ADA Curb Ramp New Construction Inspection Form (Parallel)

NW Timeric

23885.56

NW Belgium

PARALLEL RAMP (PL)

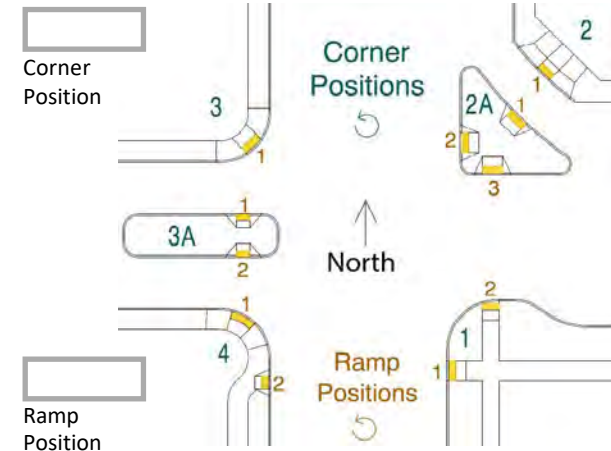
$\leq 1/4"$ ☐ $> 1/4"$ ☒

☐ 9.92 $\leq 8.3\%$ ☐ $> 8.3\%$ ☒

0.8 $\leq |5.0\%|$ ☐ $> |5.0\%|$ ☒

3.9 $\leq 2.0\%$ ☐ $> 2.0\%$ ☒

3.3 $\leq 2.0\%$ ☐ $> 2.0\%$ ☒

3.45 $\geq 4.0'$ ☐ $< 4.0'$ ☒

Comments:
NTD Fail RR 1 And TS
